Subject: Pipe Support Review Questions
Comanche Peak Steam Electric Station
Independent Assessment Program - Phase 4
Job No. 84056

PIPE SUPPORT QUESTIONS

115-1-03-007-C72K
SKETCH

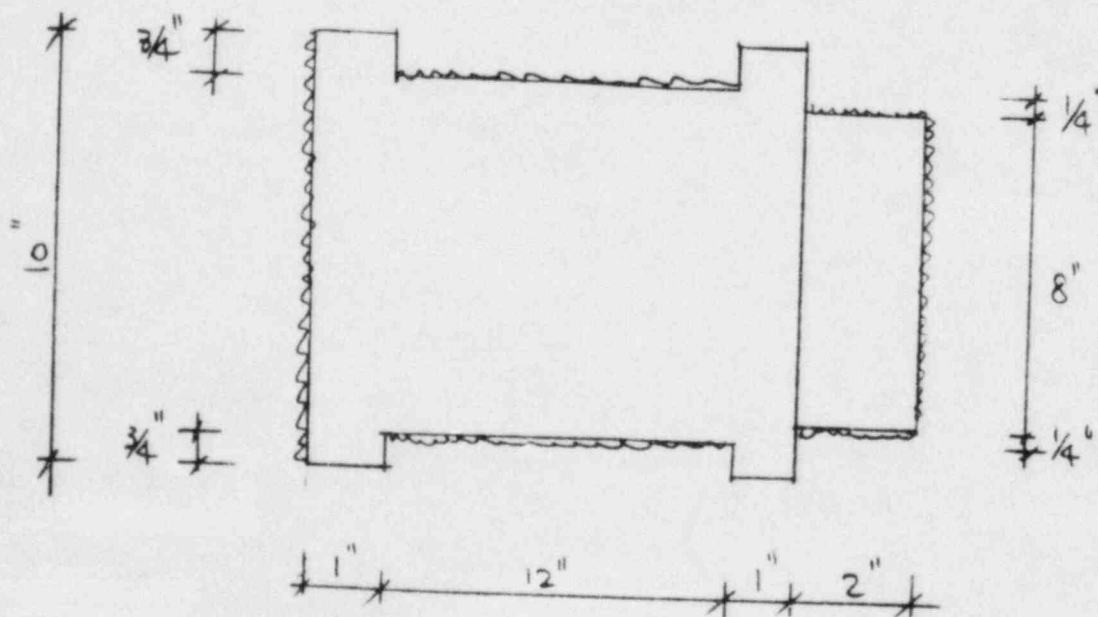
10. MS-1-003-007-C72K, drawing revision 10. In the original review of support MS-1-003-007-C72K, Cygna did not find sufficient dimensioning in section J-J detail 46 to determine where the rear bracket was welded to item 35. During the Phase 4 walkdown, Cygna was able to measure the actual dimensions as shown on the attached sketch.

- a) Did the designers size item 35 without dimensions based on assumptions which were not stated?
- b) Given the as-built data, please provide calculations showing item 35 is adequate to transfer the load from the rear bracket to item 22.
